ADDENDUM NO. 2

**STOUT FIELD BUILDING 18
MILITARY INTELLIGENCE BATTALION CONVERSION
INDIANAPOLIS, INDIANA**

IFB NO: MDI-SAB-24-B-014

GEDA Architects

EL101

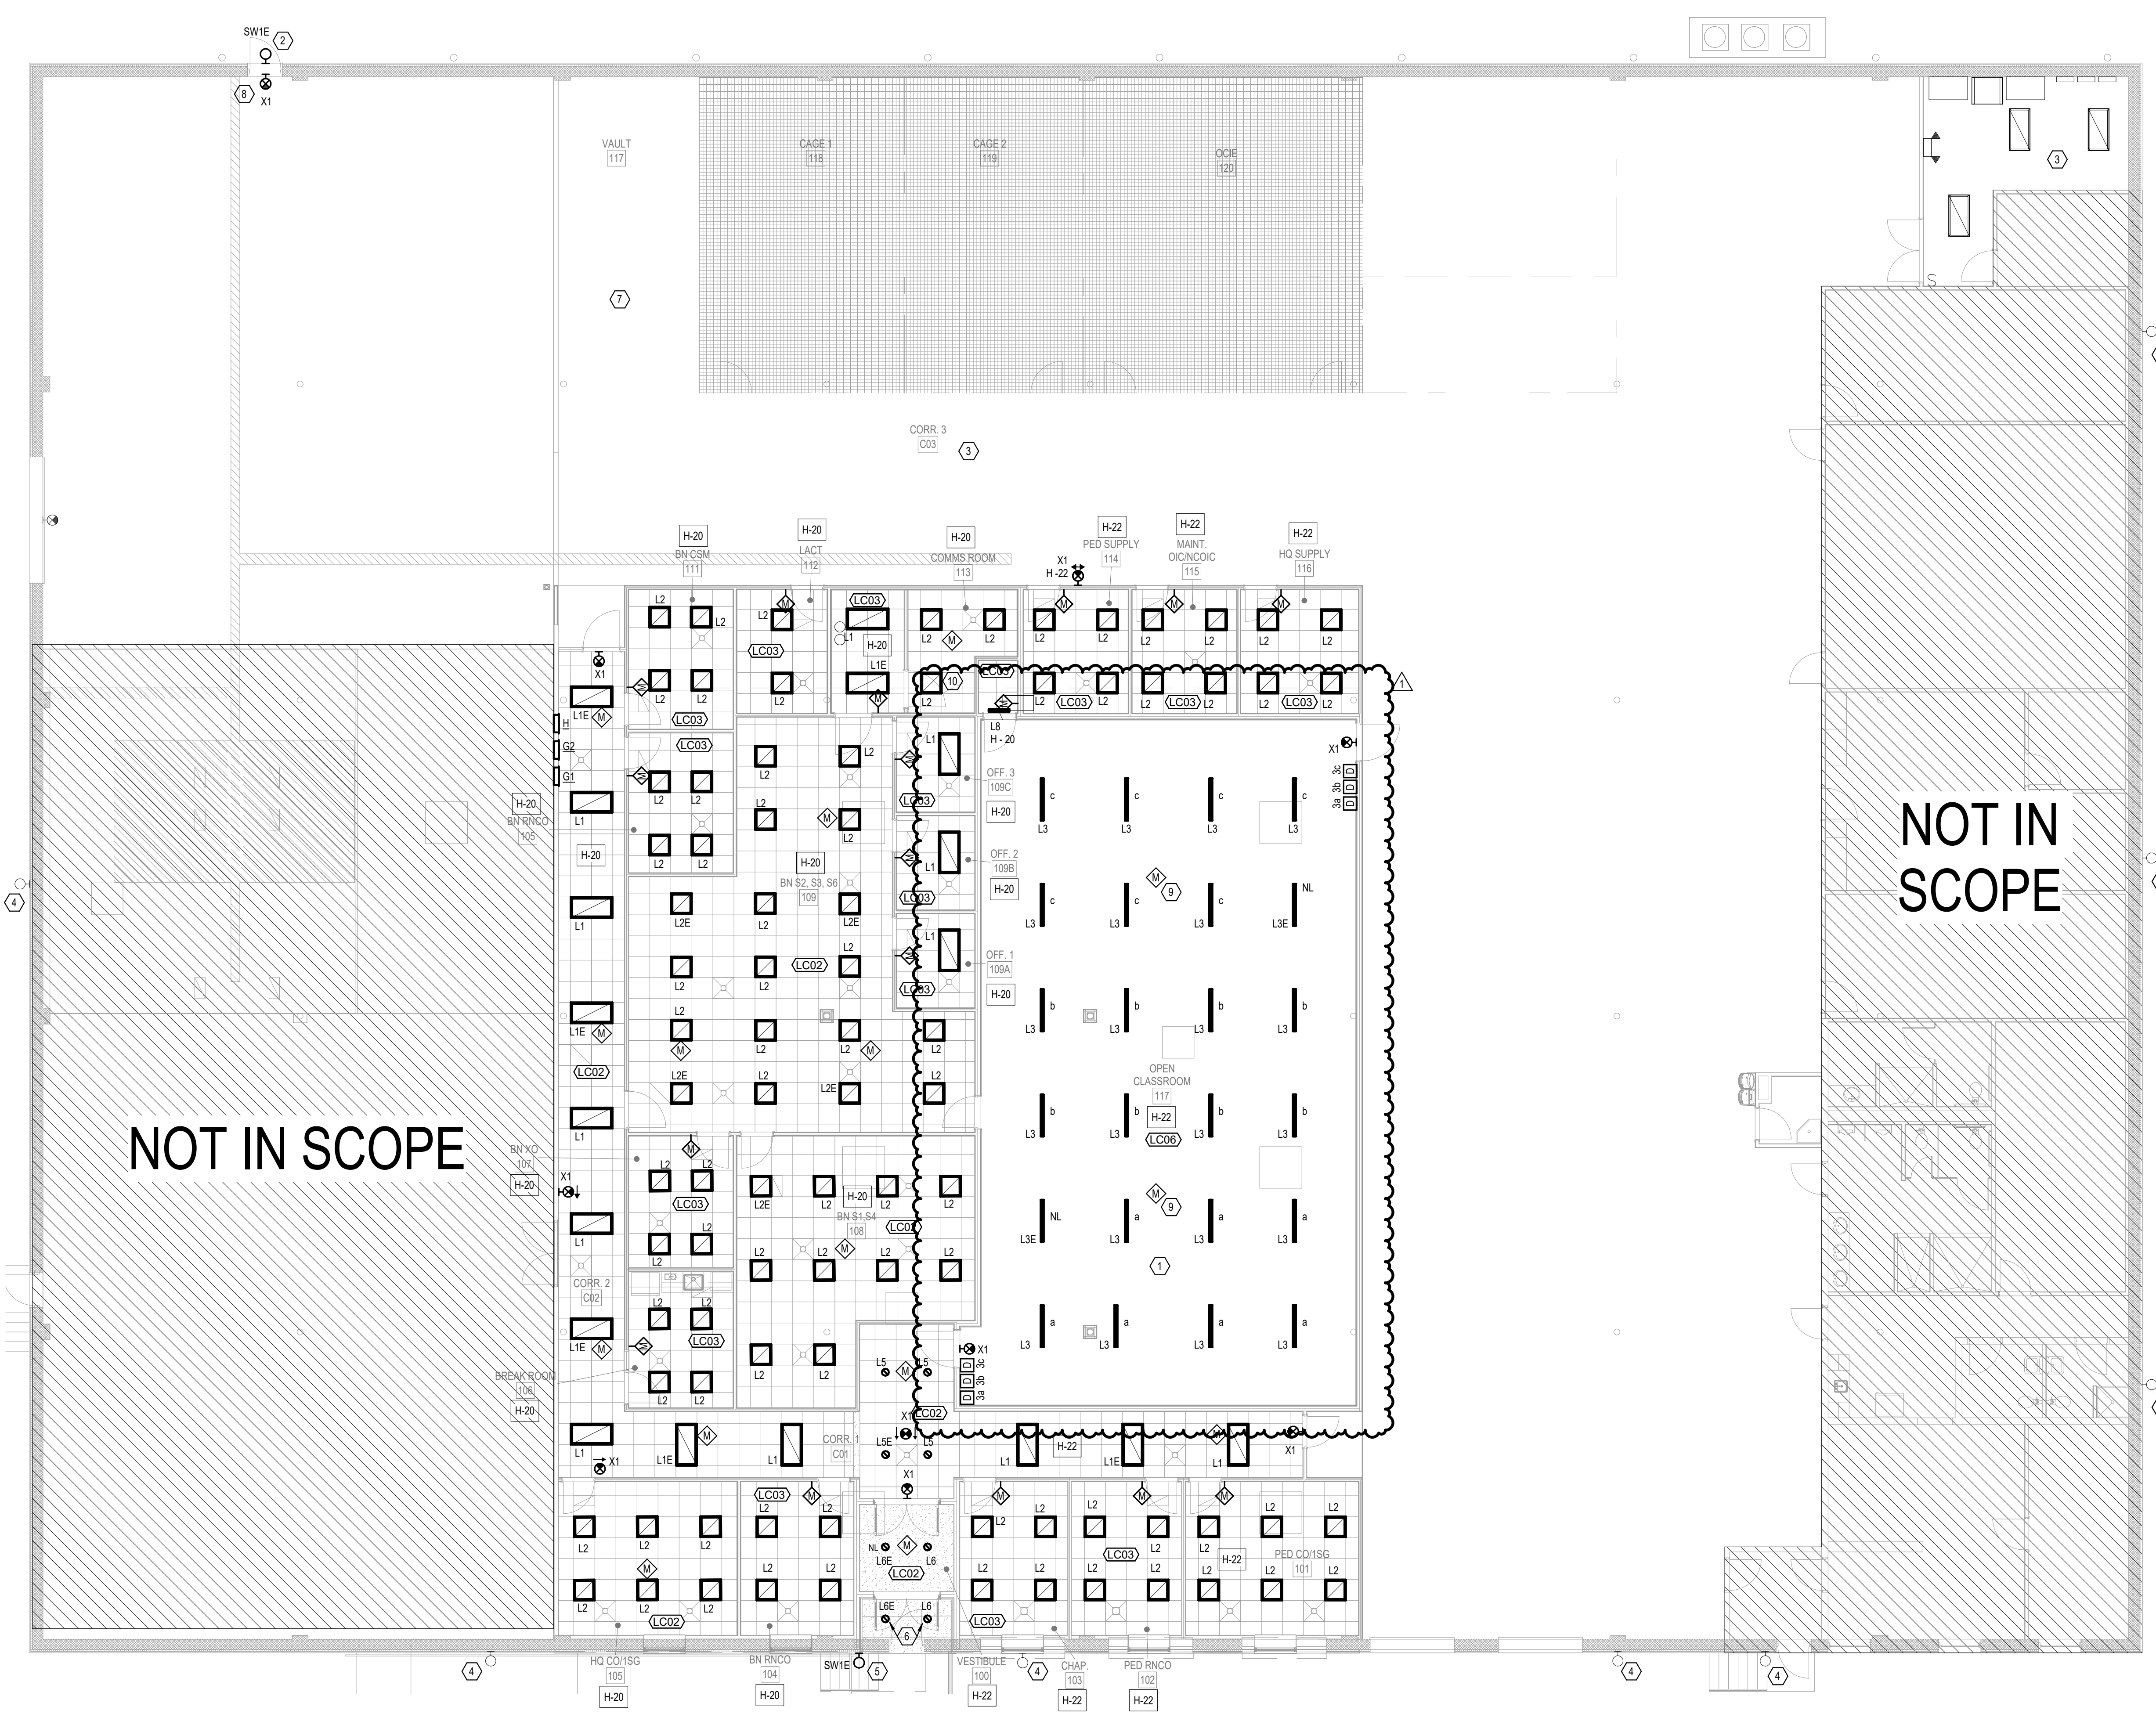
- Revised ceiling design in Room 140
4. Sheet EL101 – FIRST FLOOR LIGHTING PLAN
 - Keynote 1 revised to provide additional information on mounting of light fixtures in Open Classroom 117.

- Lighting control revised in Open Classroom 117 to show 3 zones of control and corresponding switchlegs per owner's request.
5. Sheet EP101 – FIRST FLOOR ELECTRICAL PLAN

- 1 SUSPEND FIXTURES FROM STRUCTURE USING UNISTRUT TO FALL +9'-0" AFF. COORDINATE FINAL PLACEMENT WITH OTHER DISCIPLINES SO THAT LIGHTING FALLS BELOW ALL OTHER COMPONENTS.

T101

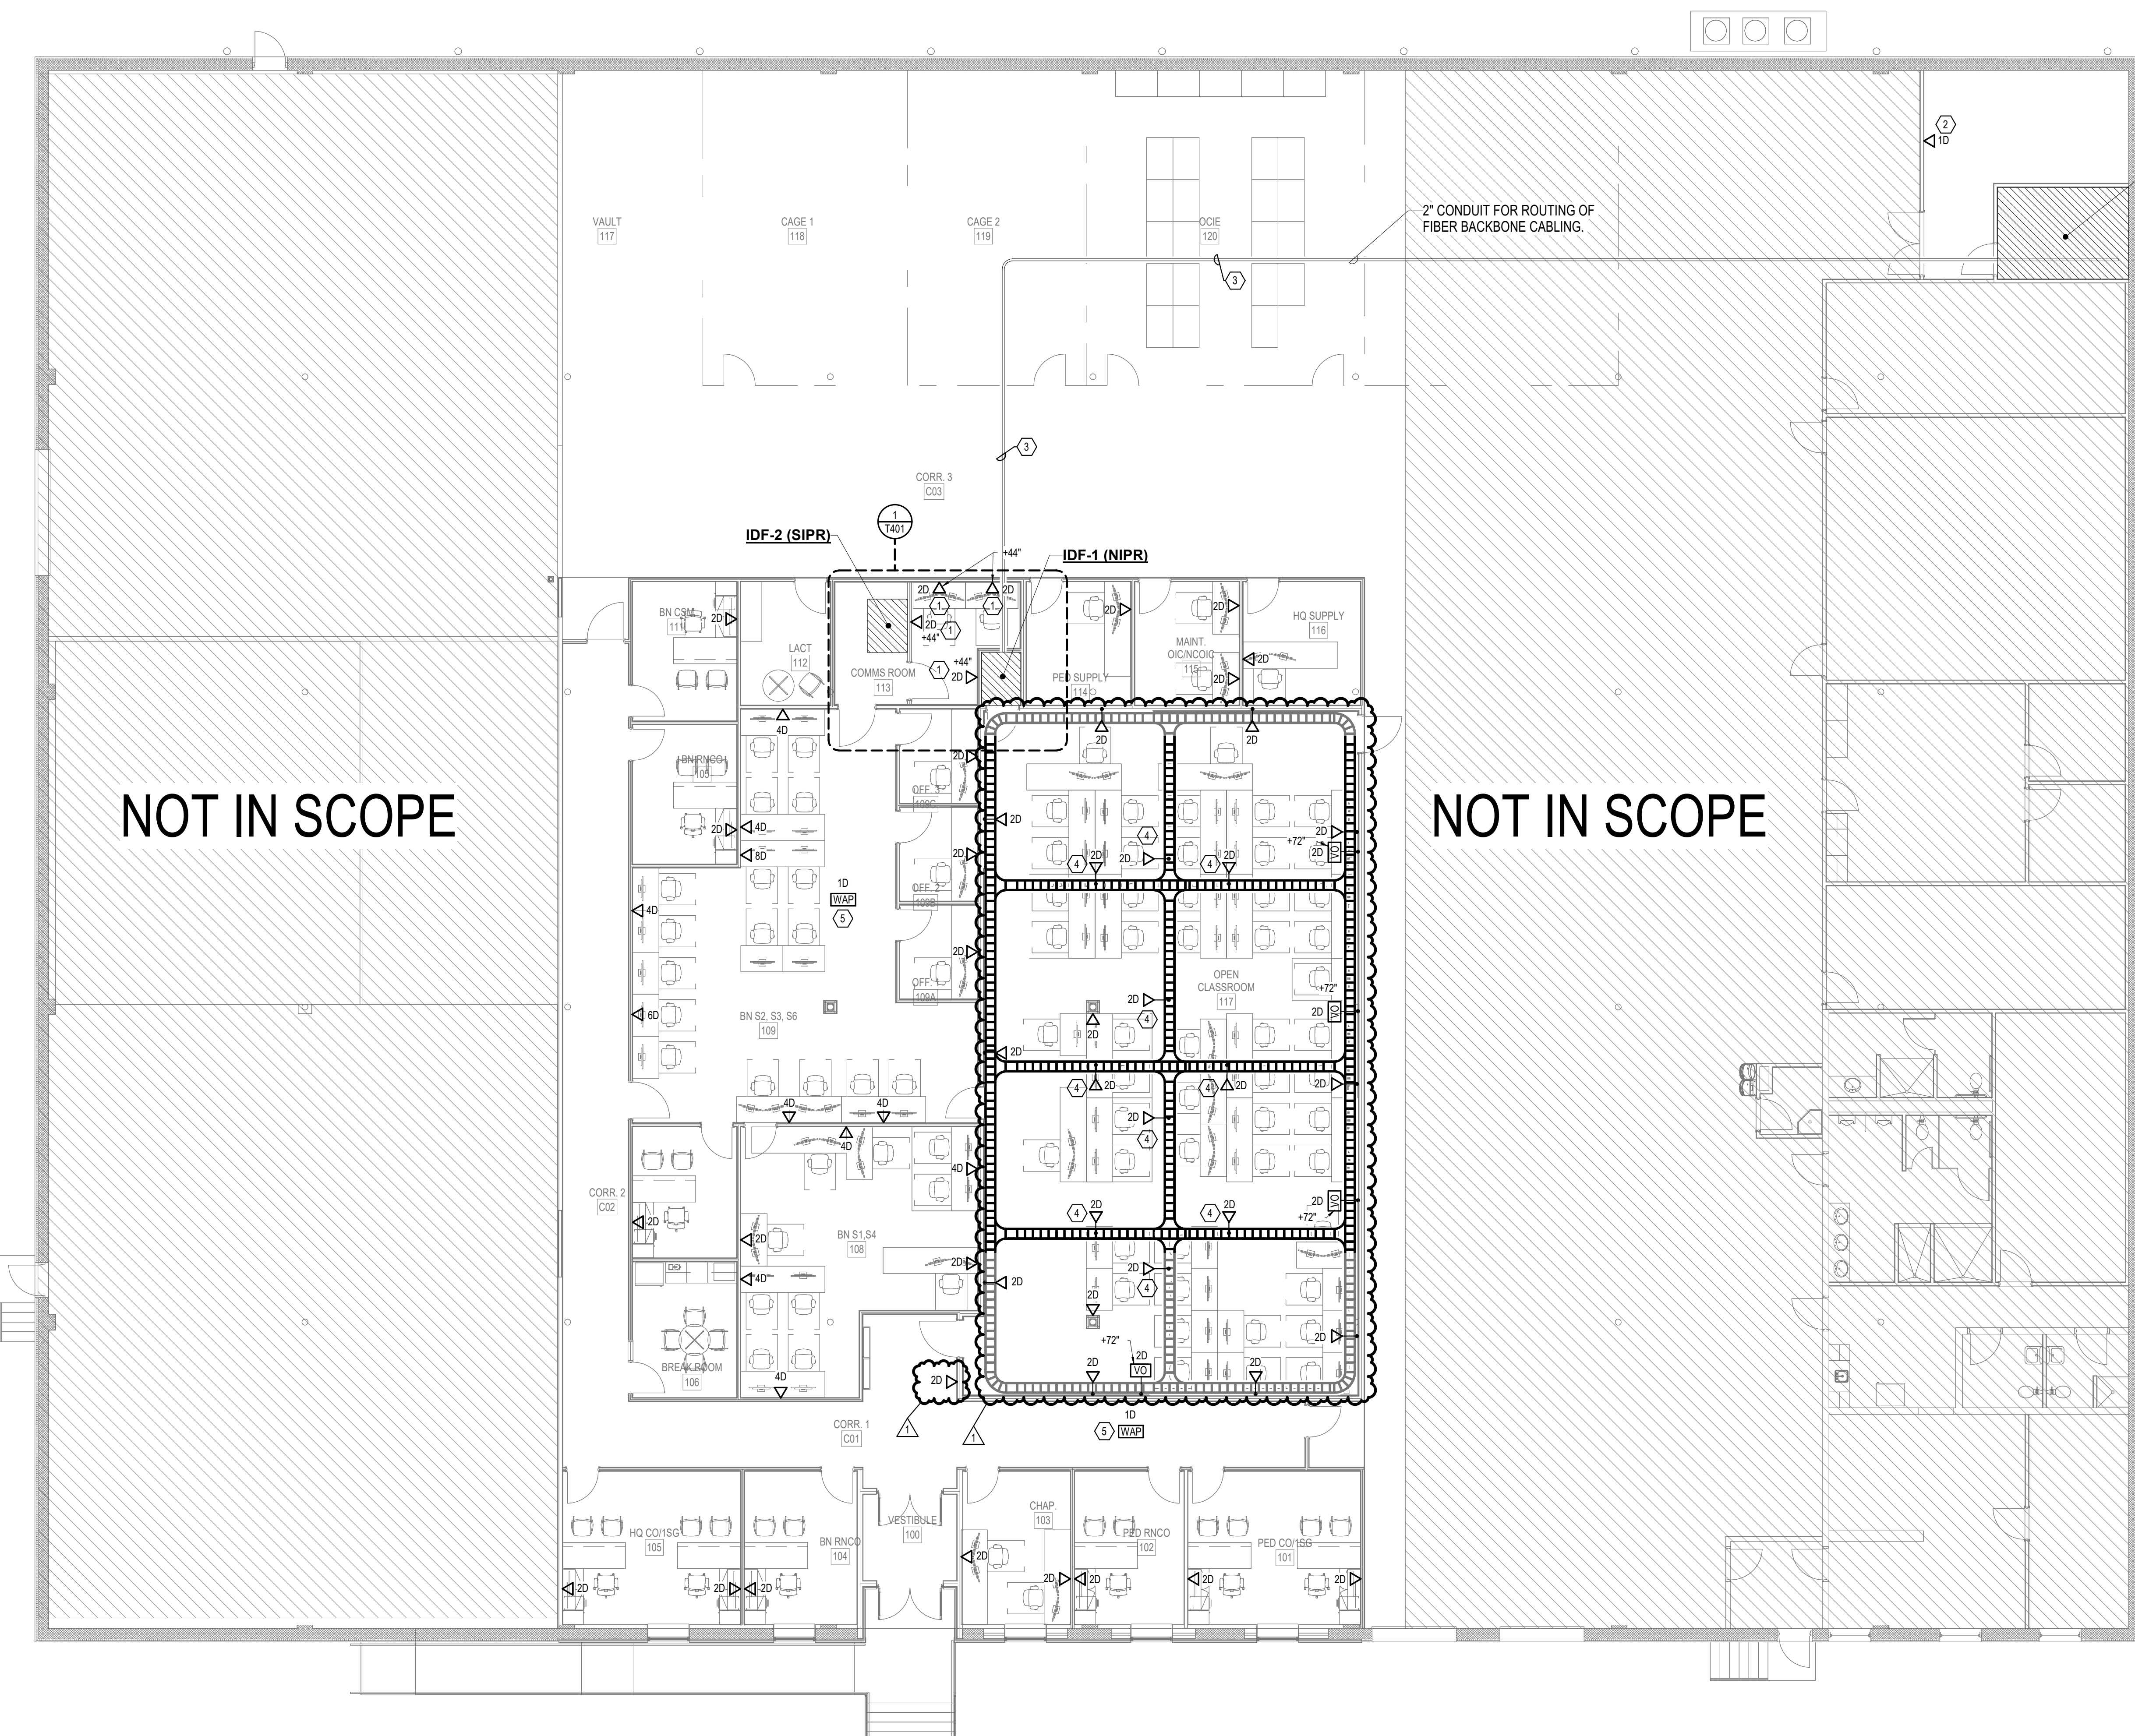
- Panel G1 - Increased panel from 42 ckts to 60 ckts.
8. Sheet T101 – FIRST FLOOR TECHNOLOGY PLAN
 - Added three runs of cable tray in open classroom 107.

- Added four VO locations with two (2) data drops each in open classroom 107.
 - Added six (6) 2-port data drops to new cable tray runs.
 - Added one (1) 2-port data to future desk location outside of open classroom 107.
